ADDENDUM NO. 1

RFP-5330-147

STREET LIGHT LED RETROFIT

January 16, 2018

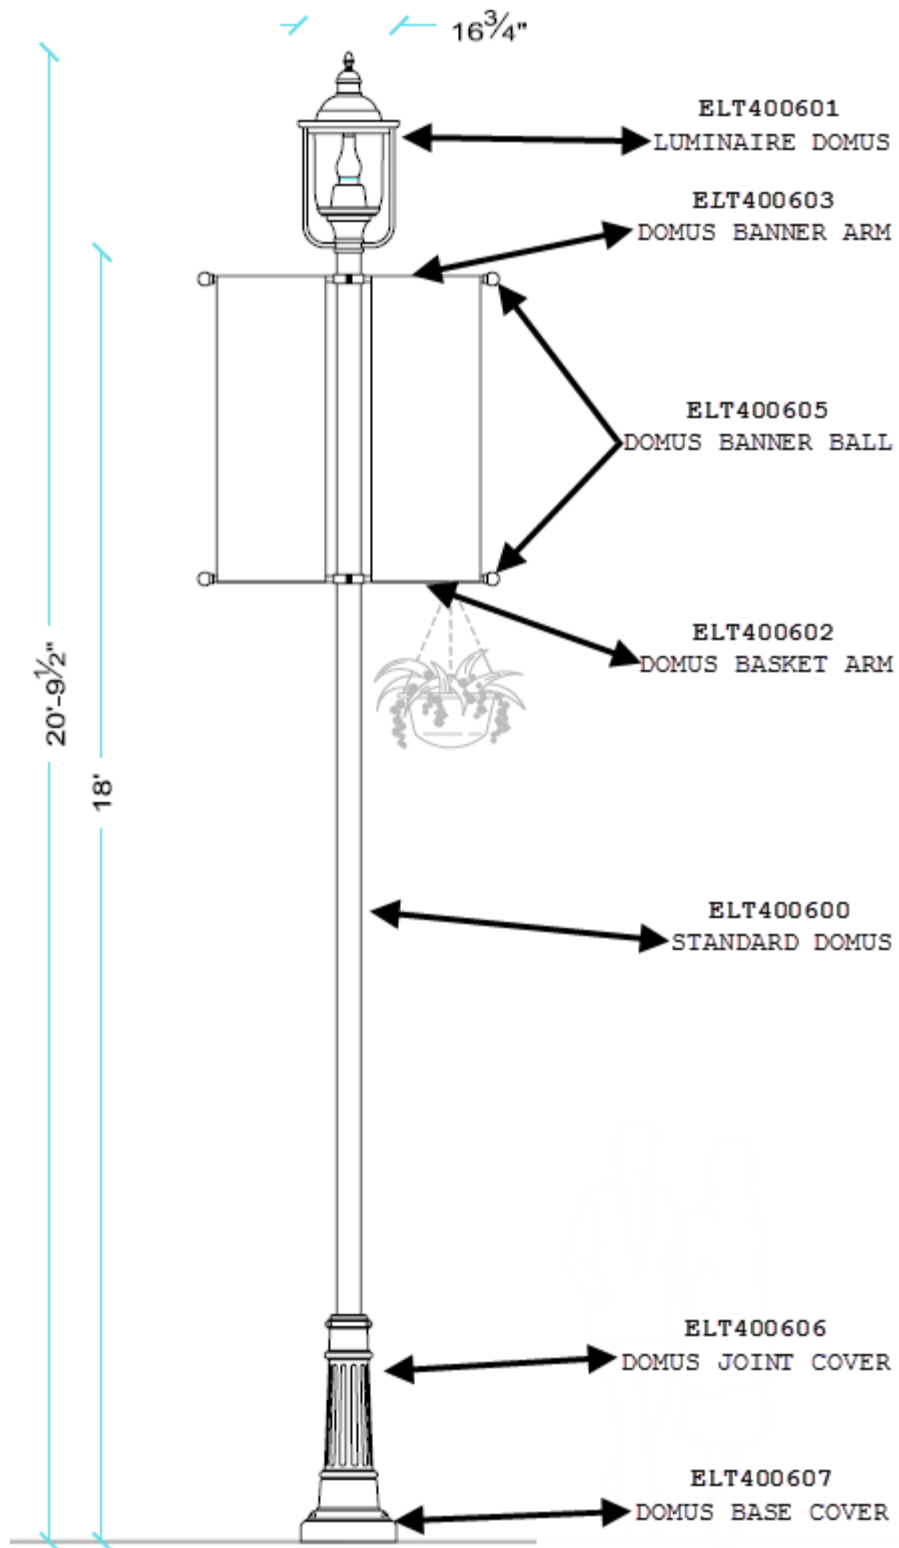
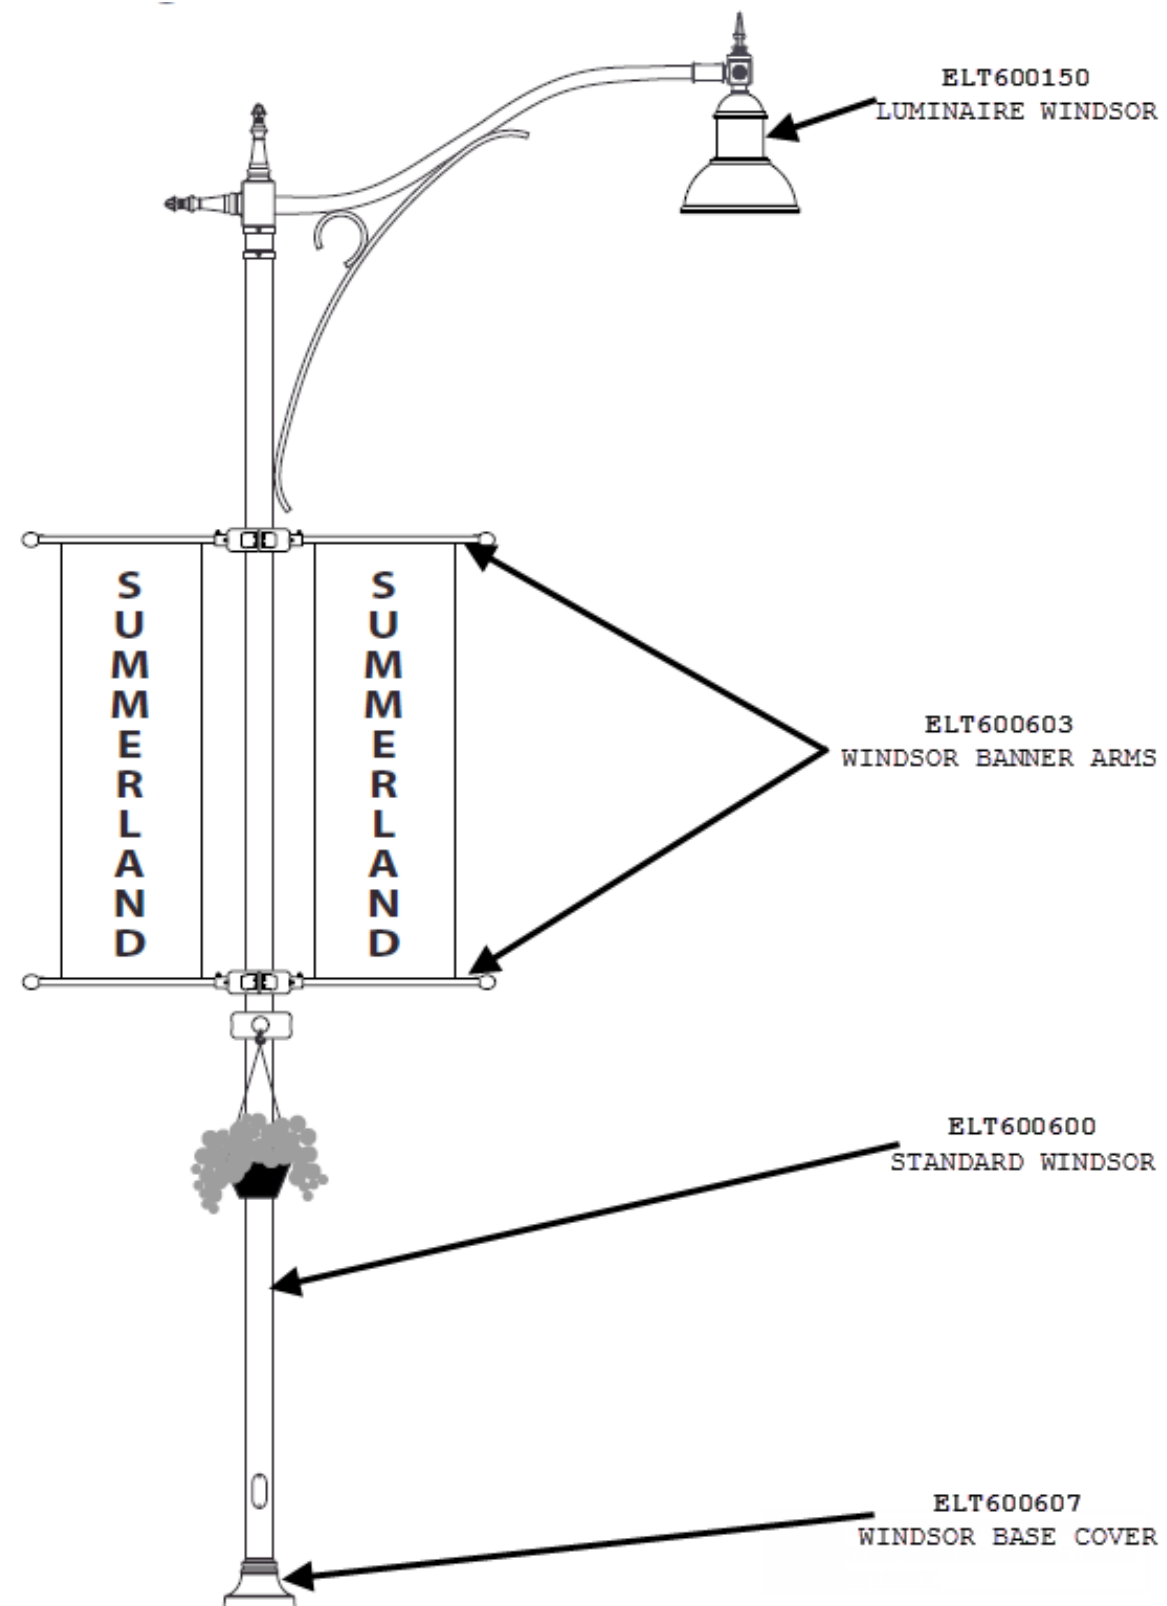
Q: Can the District provide images or drawings of the existing Decorative/Top Hat/Flood fixtures?

A: Drawings with further information regarding the Decorative and Top Hat fixtures is included below. Photos showing some of the flood light fixtures are provided; however, there are several locations and styles throughout the District.
